USNRC APPLICATION
SUA-1341 License Amendment
Ludeman Project
Converse County, WY

June 2013

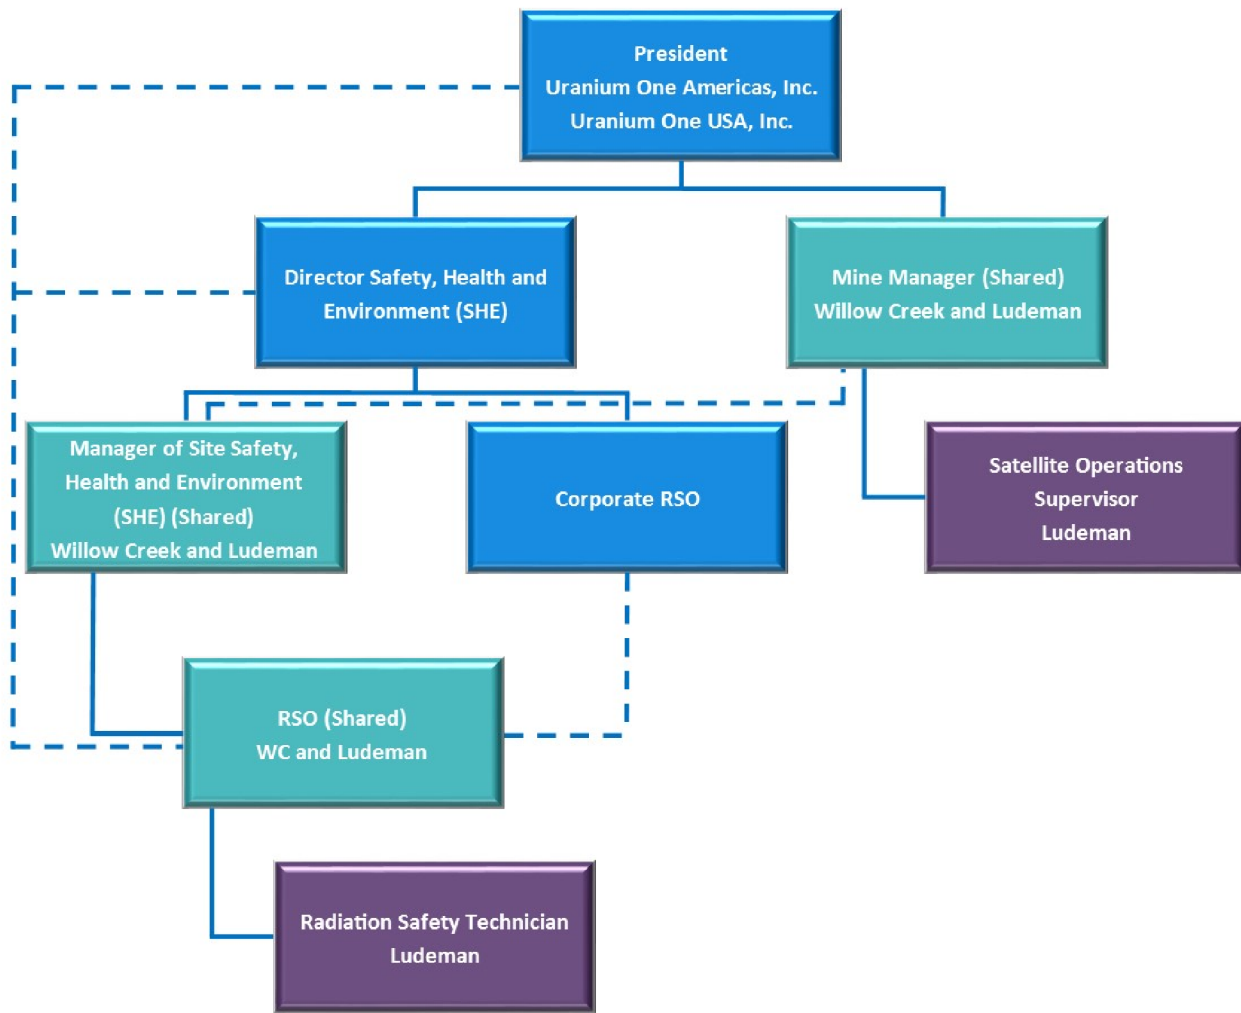
Section 5.1, Figure 5-1 is titled, “Uranium One USA, Inc. Organizational Chart”

Uranium One should revise Sections 1 and 5 of the TR, and all other applicable sections of the TR, to provide a consistent management structure for the Ludeman facility.

Management positions described in Sections 5.1.1 – 5.1.8 of the TR are not always consistent with the organization chart provided in Figure 5-1.

Sections 5.1.4, 5.1.5, and 5.1.7 reference a position titled, Manager Site SHE. Figure 5-1 identifies a position titled Manager Satellite SHE

Uranium One should revise Section 5.1 of the TR, and all other applicable sections of the TR, to ensure that the management positions identified on Figure 5-1 are consistent with the position descriptions described in Sections 5.1.1 – 5.1.7.

Text and figures concerning organizational structure have been revised throughout the application to clarify and provide a consistent management structure. Revisions to specific sections are provided below:

Figure 5-1 was be modified to indicate the position as Manager Site SHE. The position of Director of Operations was eliminated on Figure 5-1 and its corresponding responsibilities will be incorporated into the Mine Manager position. See RAI-1 for the revised organizational structure figure and position descriptions.

Figure 2: GCC Stability Class Distribution

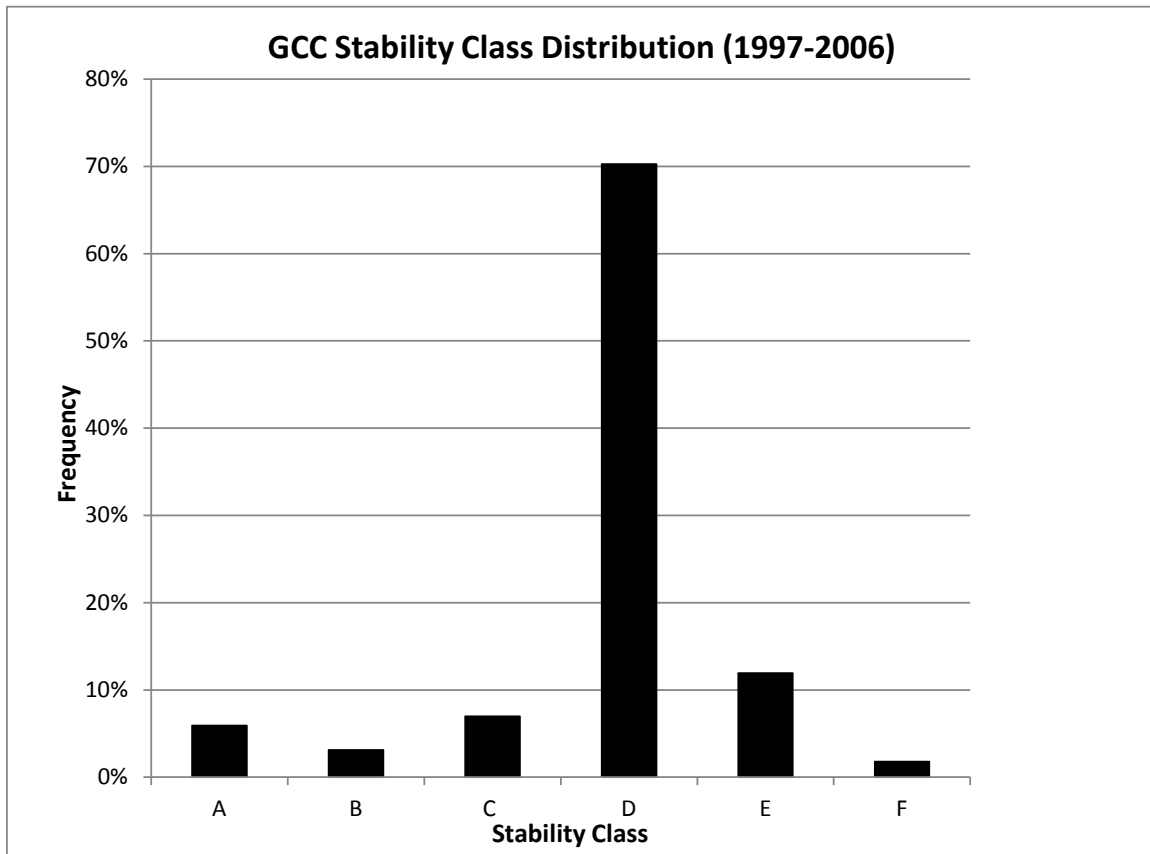
Provide the relative frequency of each stability class for the Douglas Airport and GCC meteorological stations, and describe how these stability classes were determined

The figure below shows the atmospheric stability class distribution at GCC for the 10-year period from 1997 through 2006. Note that the NWS station at Douglas Airport does not log sigma theta; therefore hourly stability class cannot be determined. Note also that in keeping with the above response to TR RAI 3, the on-site stability class distribution for the Ludeman Project will be generated at the end of the baseline monitoring period.

Table 2: Known Permitted and Existing Oil/Gas Wells in the Project Area and Within 2 km of the Project Boundary

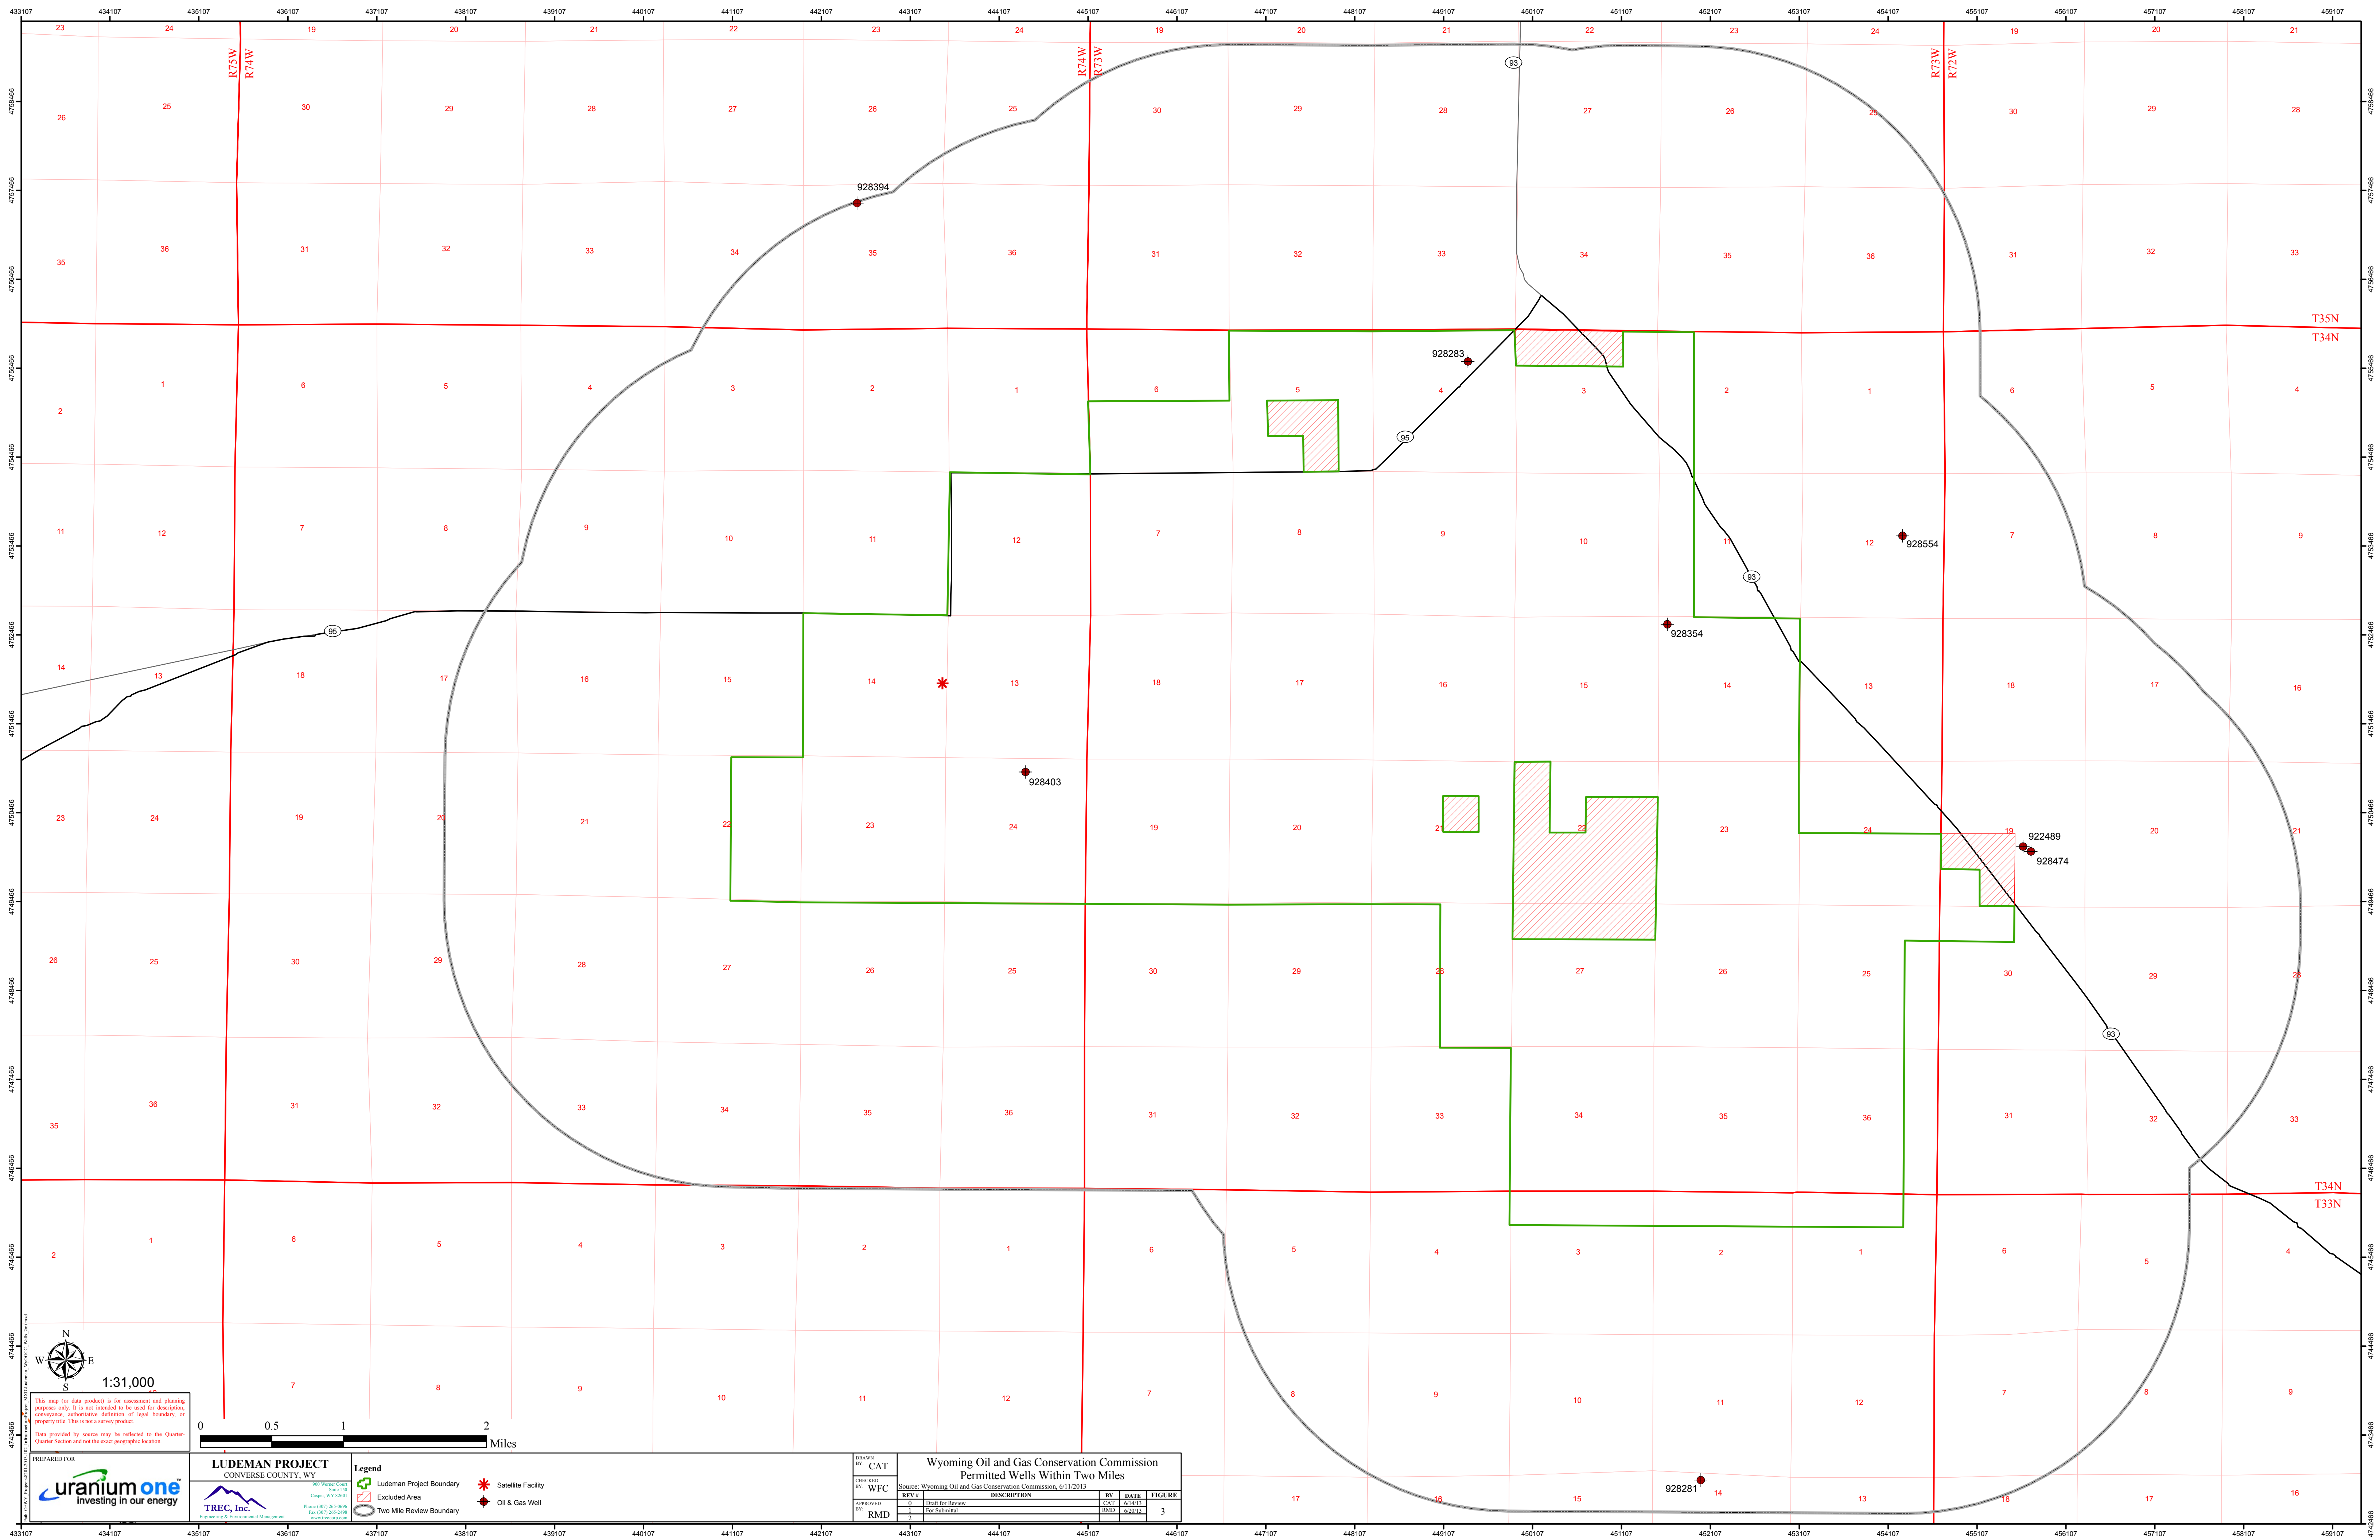
Uranium One reported in Appendix A-1 on page A-7, which was revised in December 2011, that there were no oil/gas exploration or development activities in or near the proposed license area. The staff has determined that, based on the August 2012 site visit and a search of the Wyoming Oil and Gas Conservation Commission database, there are several active oil and gas permits and wells, in and near the license area (see Table below). The application should be revised to include:

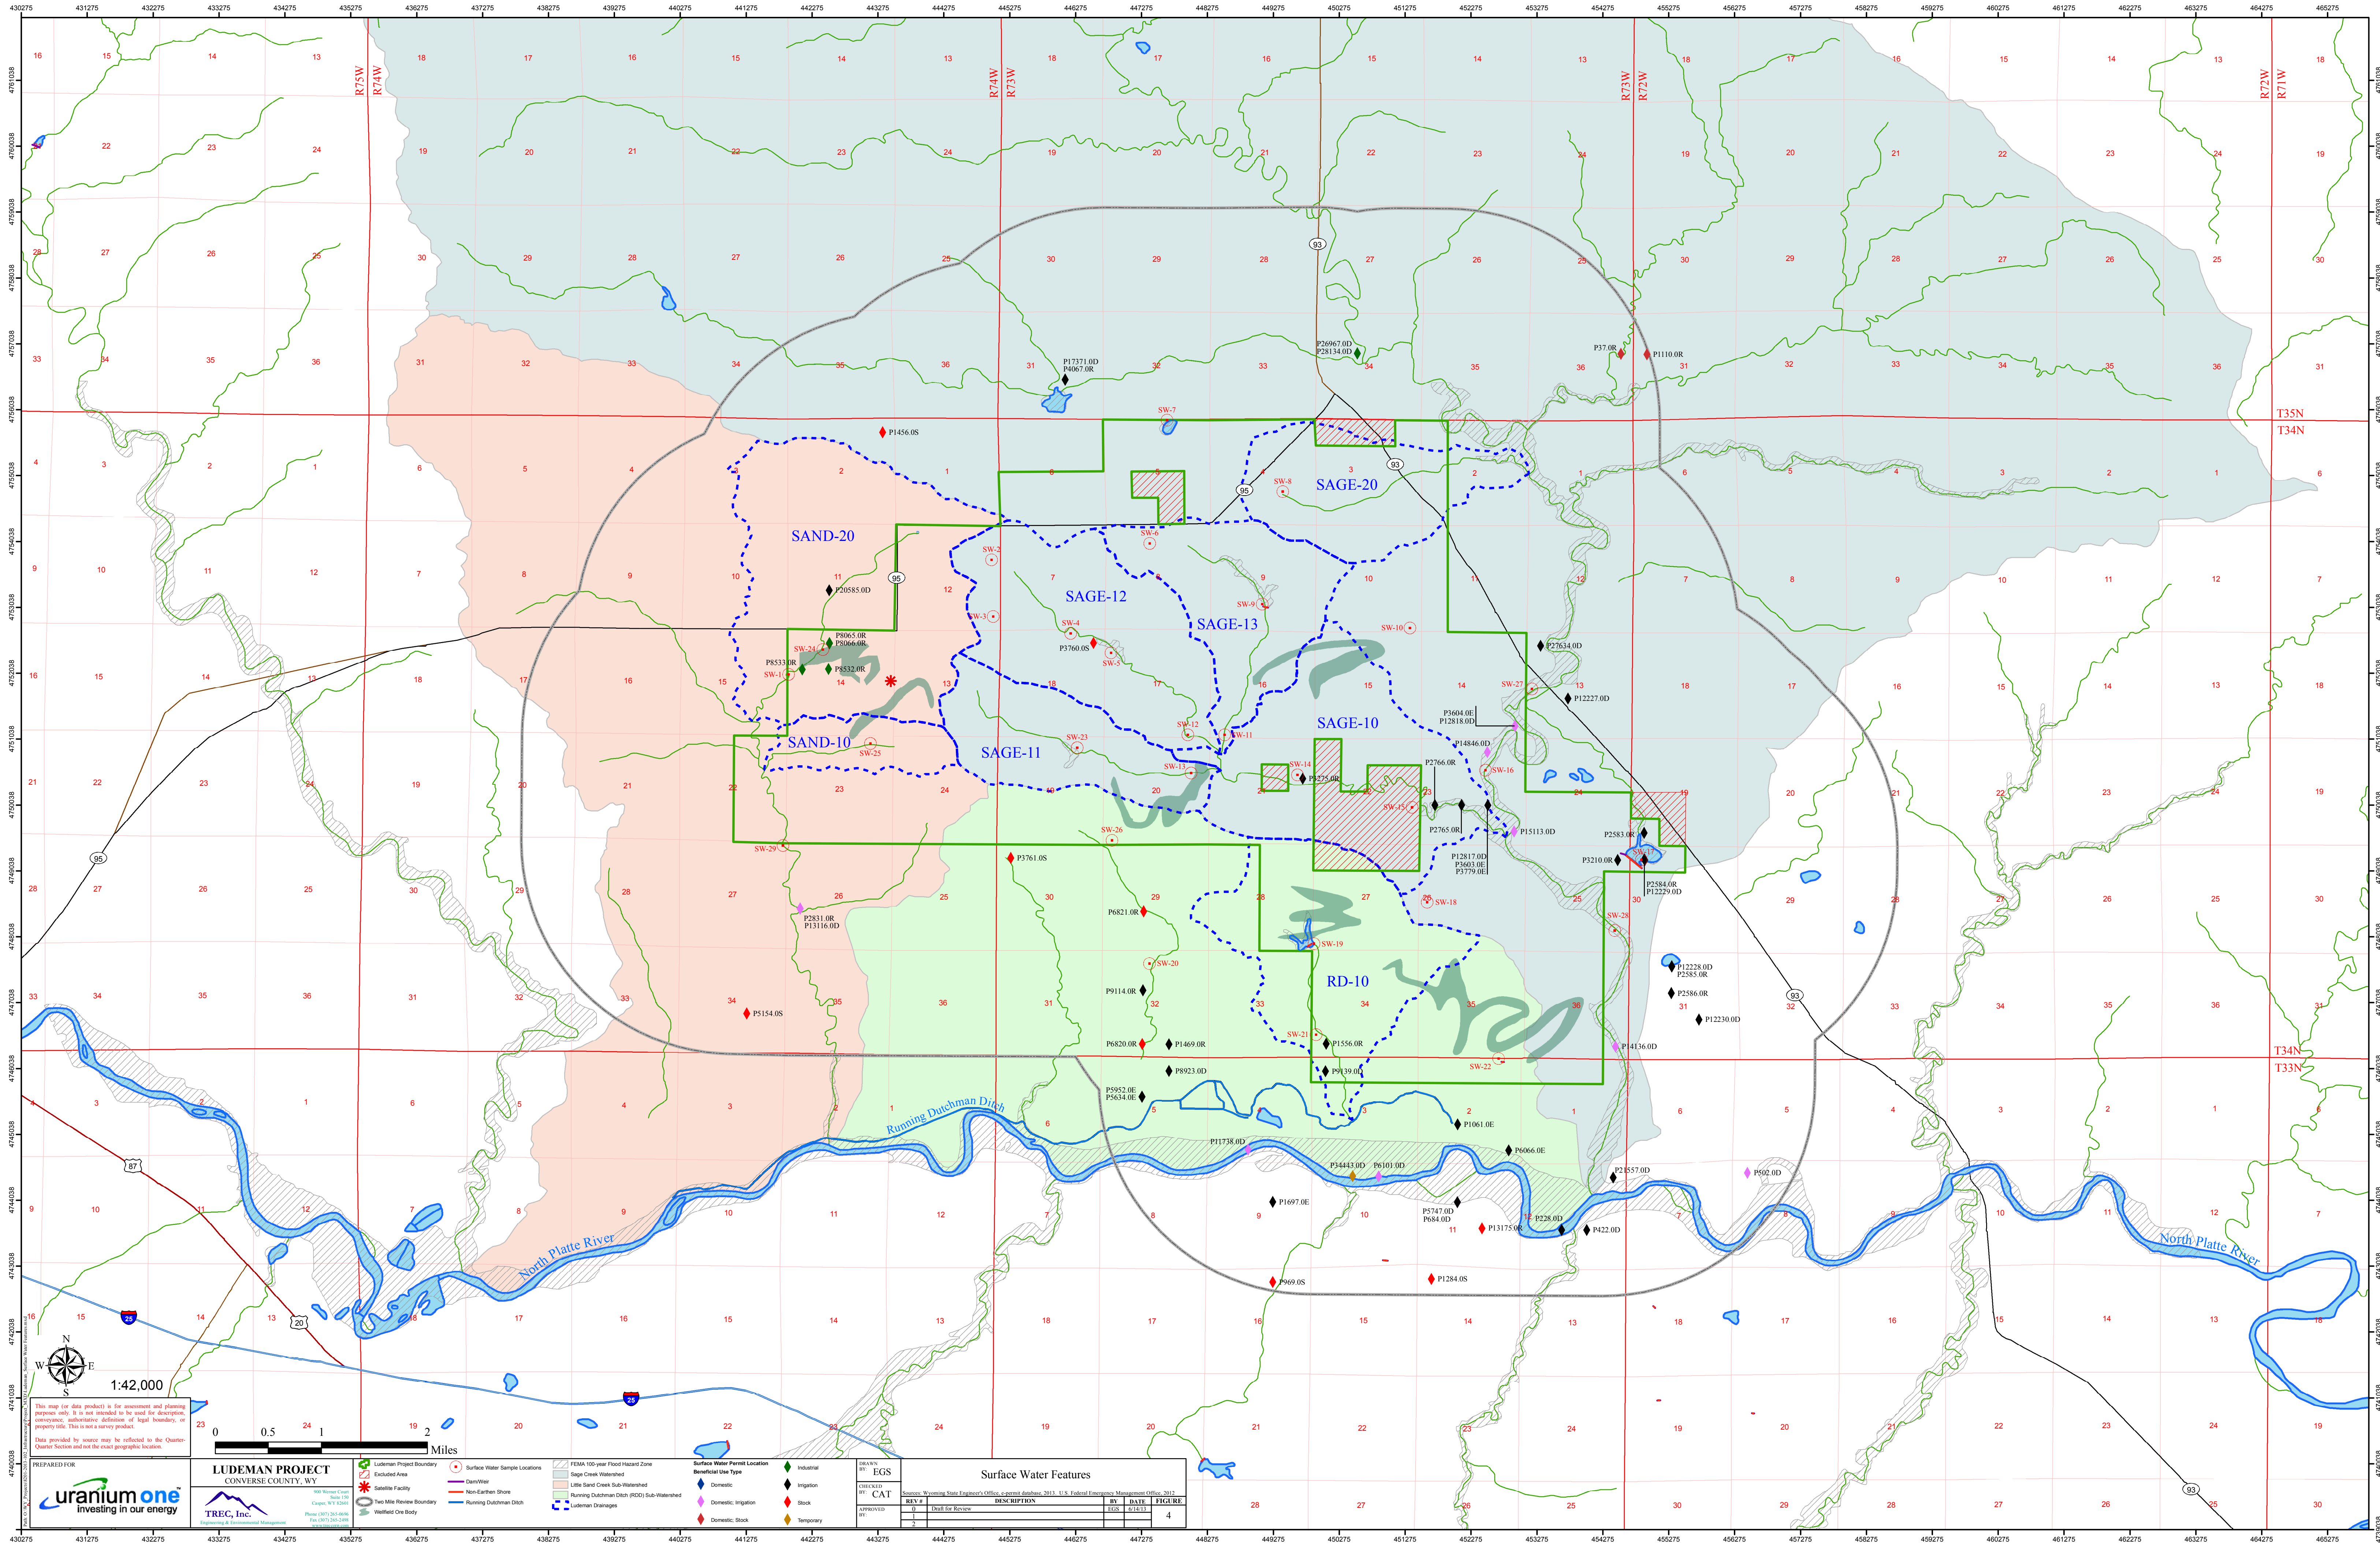
Uranium One identified eight smaller drainages within the sub-watersheds in the license area which are shown in Figure 2.7.2 of the TR. The location of the satellites and wellfields were not shown on this figure.

Staff was not able to assess the locations of the proposed wellfields relative to the eight smaller drainages to have reasonable assurance that the drainage channels would not impact the safety of operations.

Provide maps showing the location of all proposed satellite wellfields relative to the eight smaller drainages.

The following figure is now included in Section 2.7 and depicts the proposed wellfields relative to the six smaller drainages:
